STAFF RECOMMENDATION 1406 Fifth Avenue North June 15, 2016

Application: New construction—addition, reconstruction, outbuilding (detached accessory dwelling unit)

District: Germantown Historic Preservation Zoning Overlay

Description of Project: Application is to reconstruct a front porch and construct a side porch and outbuilding that includes a detached accessory dwelling unit.

SCREENED PORCH ELEVATIONS

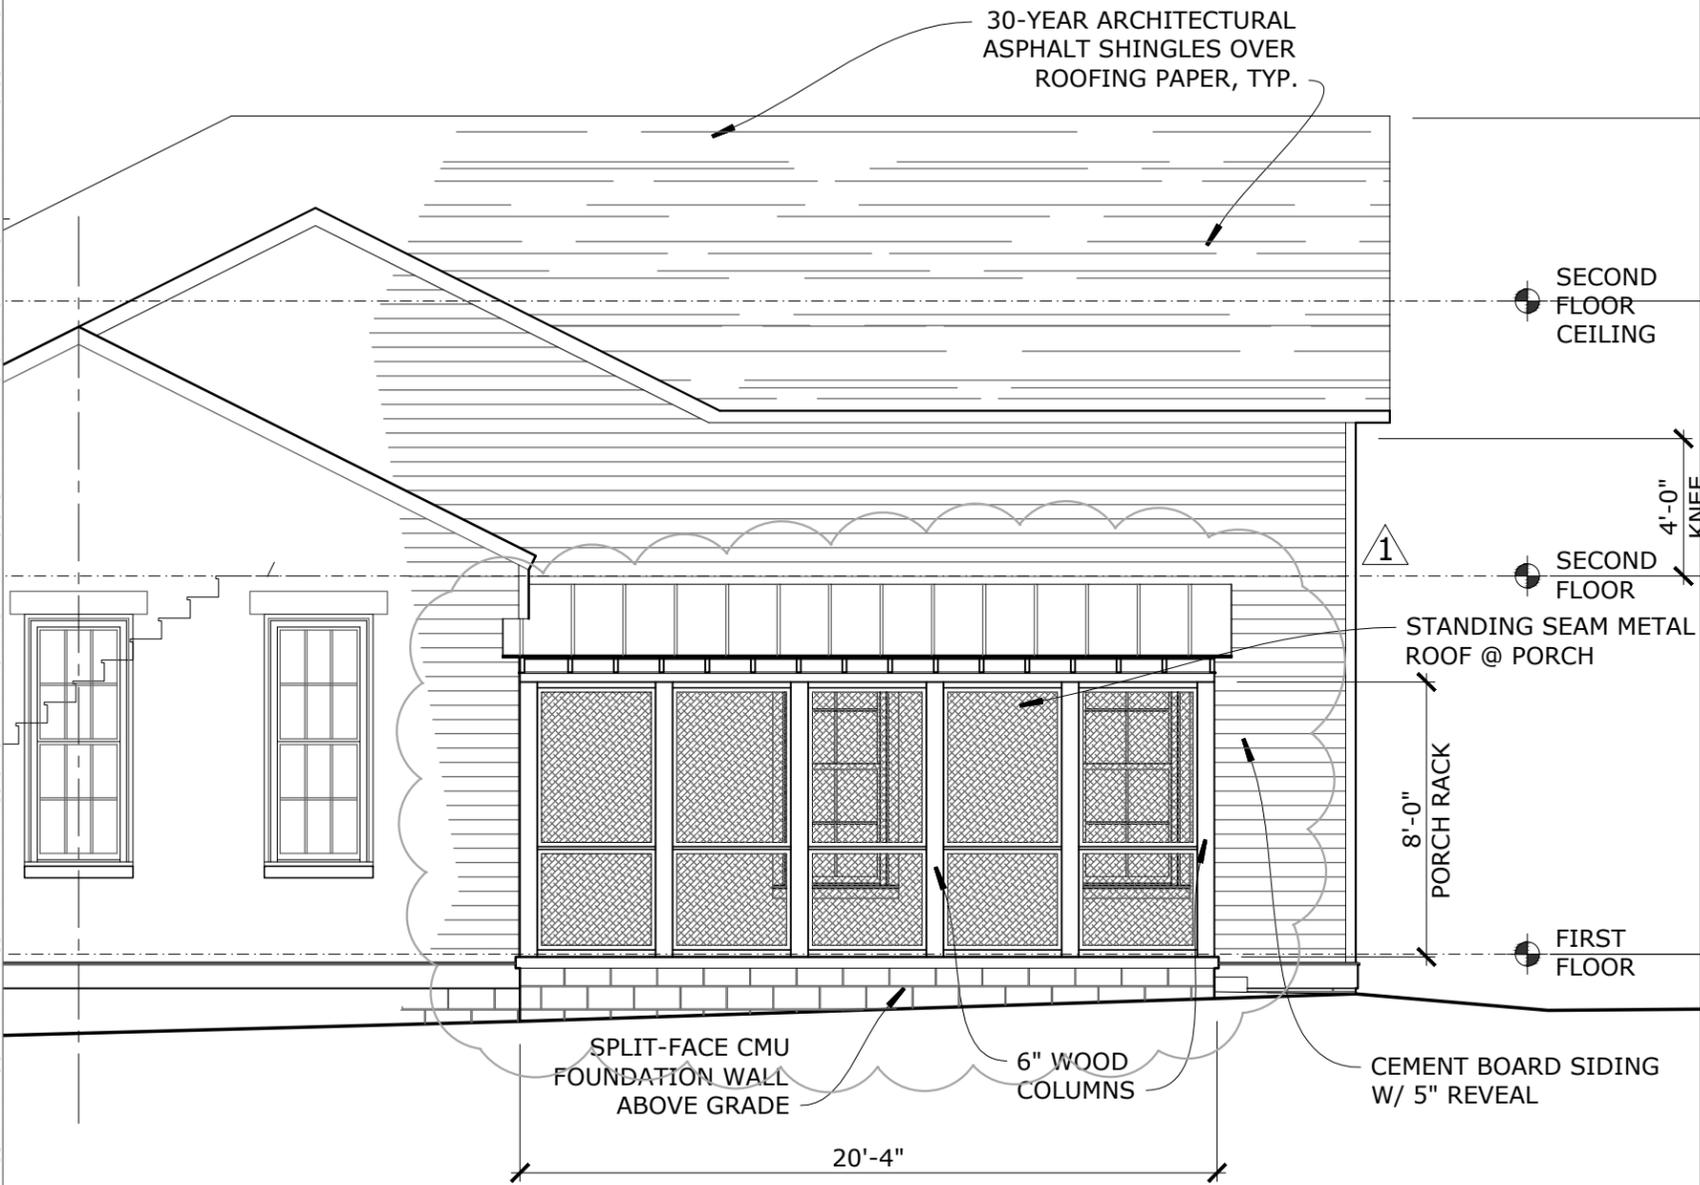
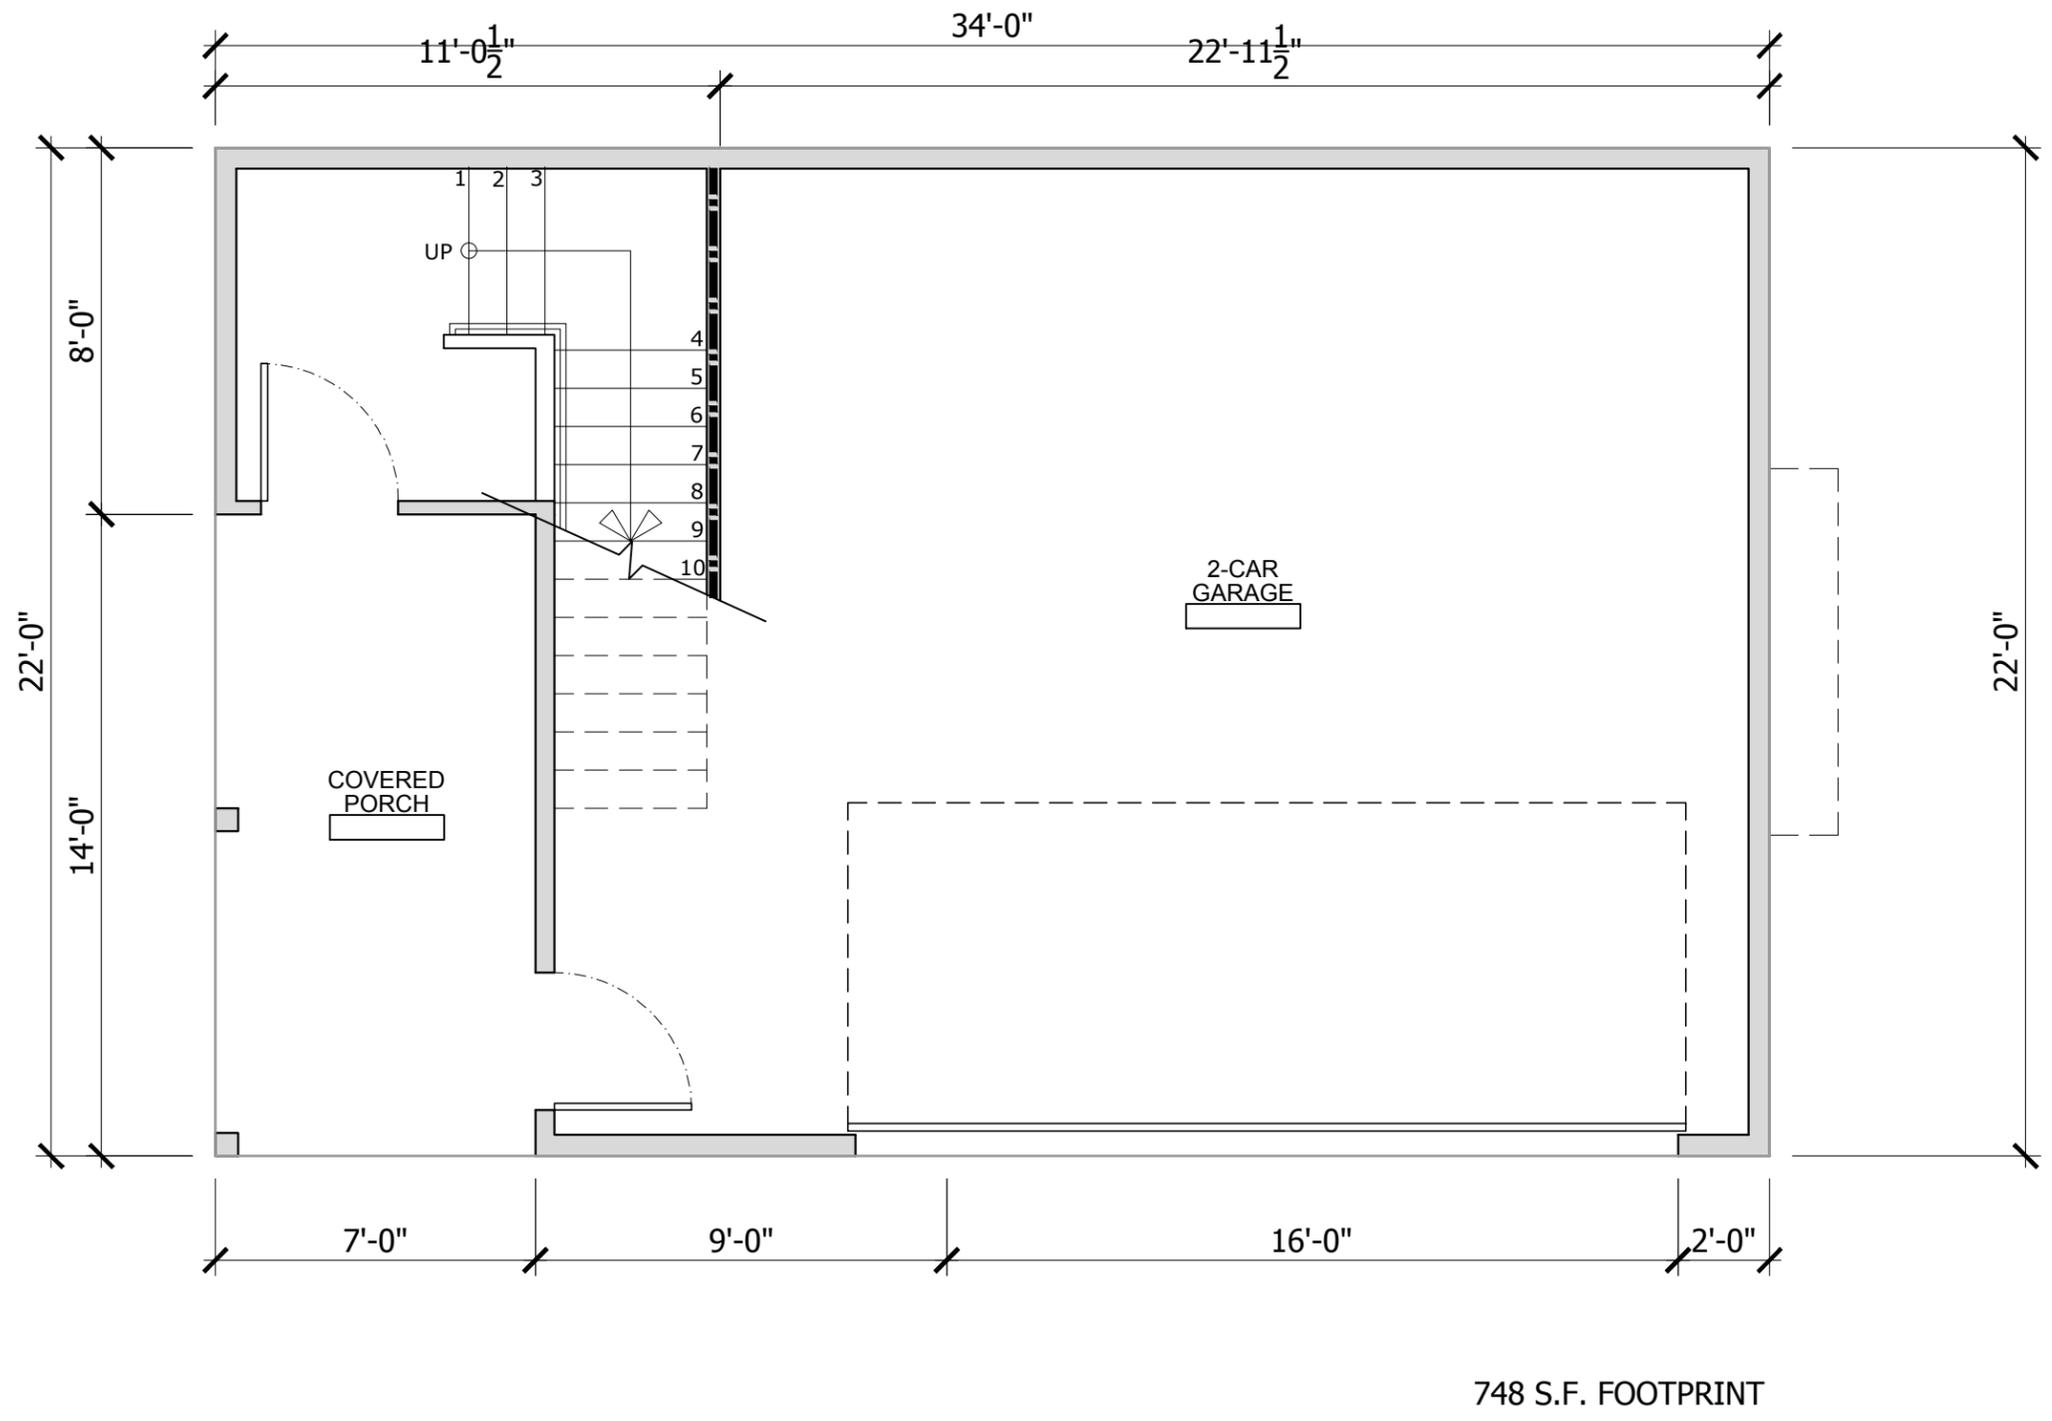
Location and Removability: This application also includes a new side porch on the right side of the addition that was approved in 2015. The porch will begin approximately seventy feet (70') back from the front of the house. The primary massing of the addition is stepped in two feet (2') from the side of the house, and the new porch will step back out six feet (6'), four feet (4') out beyond the silhouette of the historic house. In general it is not appropriate for additions to be wider than an historic house; however in this case the house is very narrow at twenty-eight feet (28') wide, and as early as 1914 it had a side addition in roughly the same location. In addition, the extension happens so far back on the property, it will be minimally visible. For these reasons, and because the addition is set so far back into the lot, Staff finds the location of the proposed new porch to be appropriate and that it meets section 4.2.5 of the design guidelines.

Materials: The porch will have a split-faced concrete block foundation, wood columns, and a standing seam metal roof. With the condition that the color of the metal roof is administratively approved, staff finds that the addition will meet Sections 2.4 and 4.2.2.

FIRST FLOOR PLAN - GARAGE

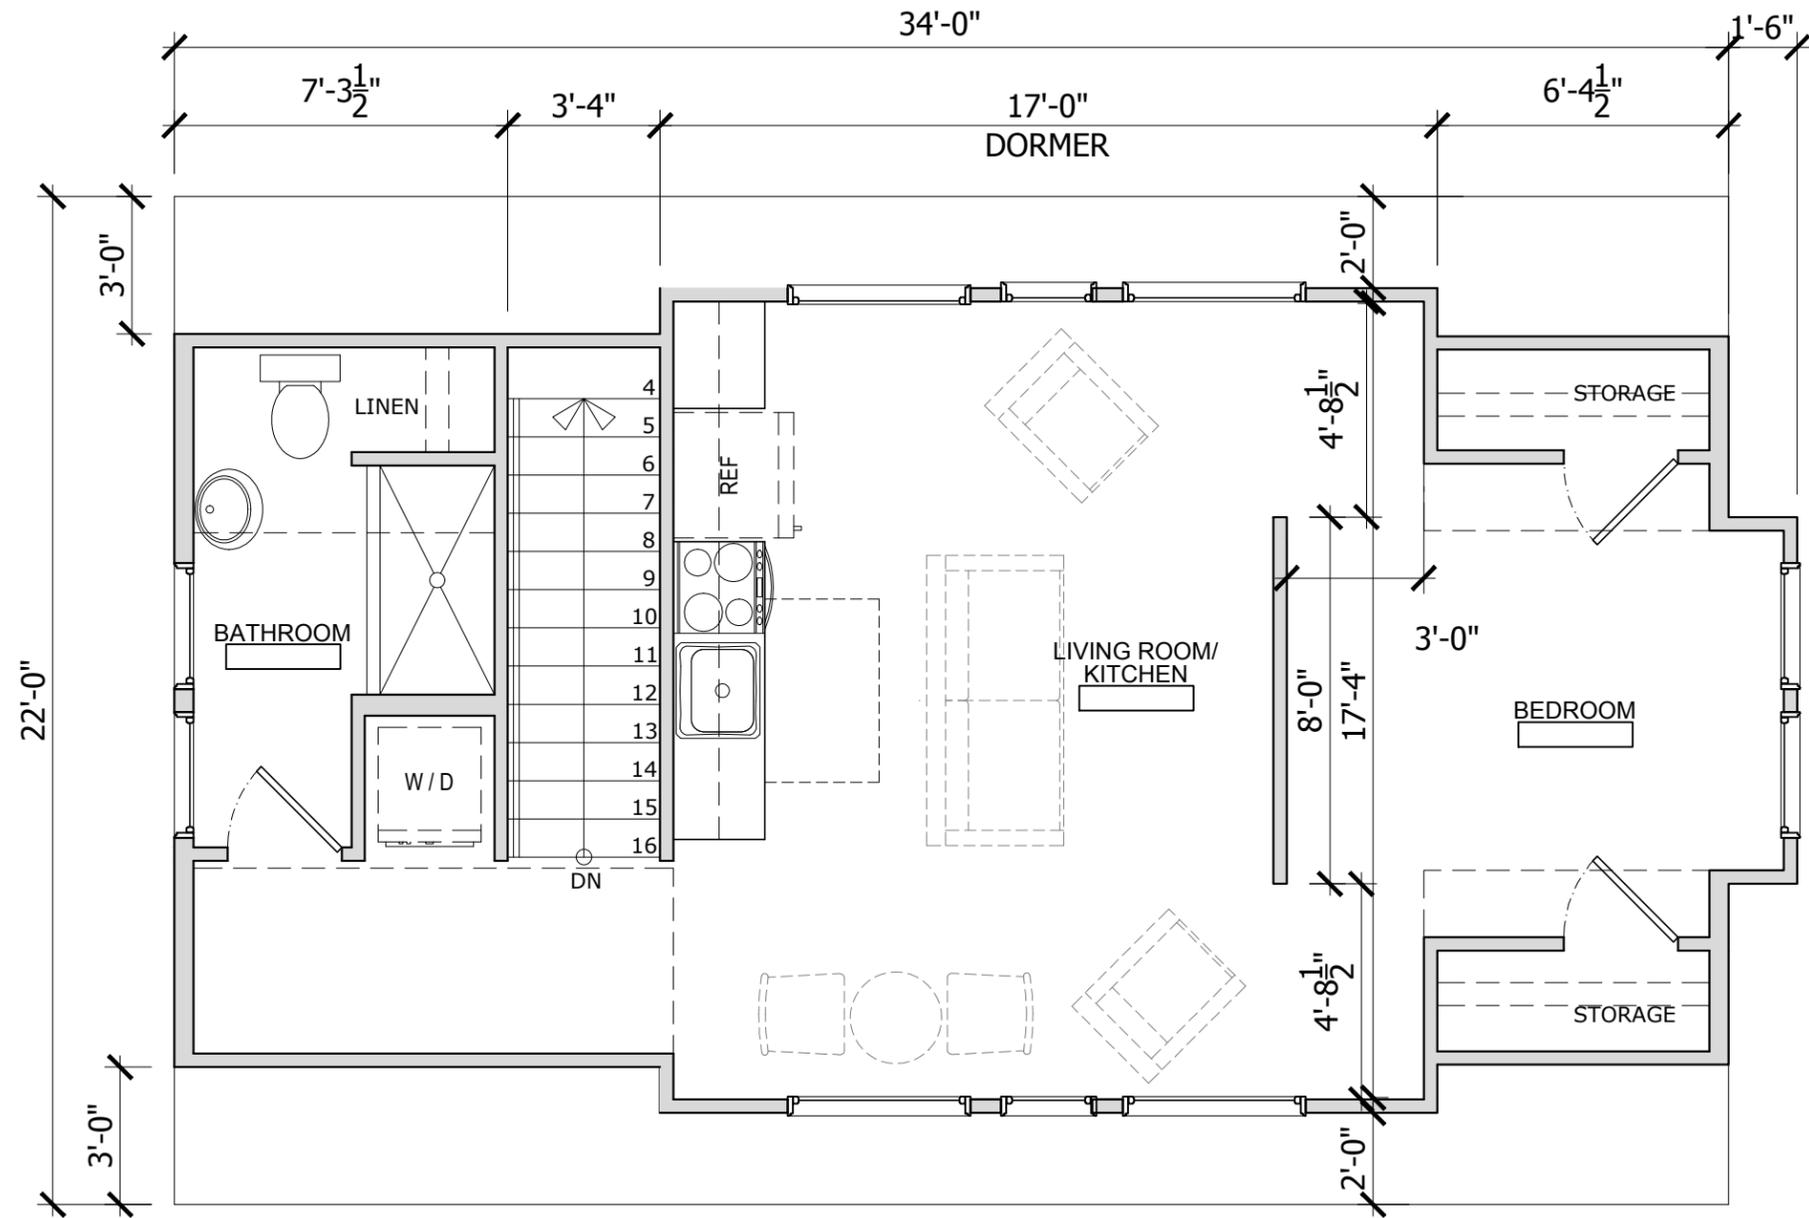
Outbuildings: The applicant proposes to construct a one and one half-story outbuilding with a first story garage, and a full dwelling unit above. The footprint size, as well as the eave and roof heights of the outbuilding would be compatible with the principal building, and would meet section 2.9 of the design guidelines and the standards for detached accessory dwelling units outlined in 17.16.030.G of the Metro Code.

Lot is less than 10,000 square feet	Proposed footprint
Maximum Square Footage	750 sq. ft.	748 sq. ft.
